Re: **Angleton Parks and Recreation Design Standards Manual – 30% Draft**

Please find the following responses addressing comments received on February 10, 2022, in both email and PDF format from the Department of Parks & Recreation:

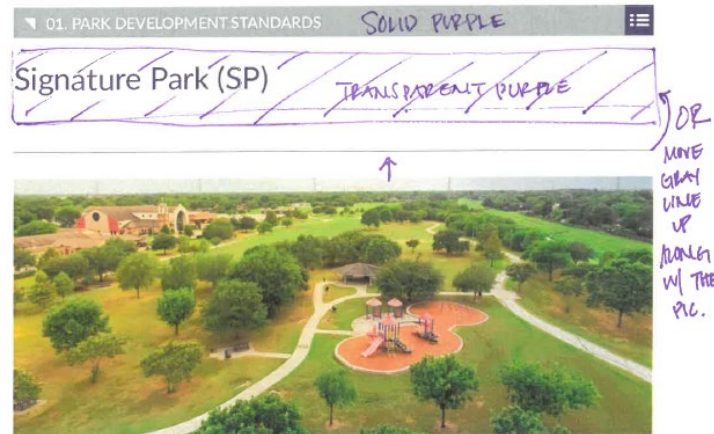
Comment 5: I’d like to see the transparent purple block that is on page 7 carried out on each park component. If it doesn’t look right once we see it this way we will need to move the gray section break line up towards to the title of each page as well as the picture. Example attached and depicted below:

**Response 5:** All headers have been updated with transparent purple header.
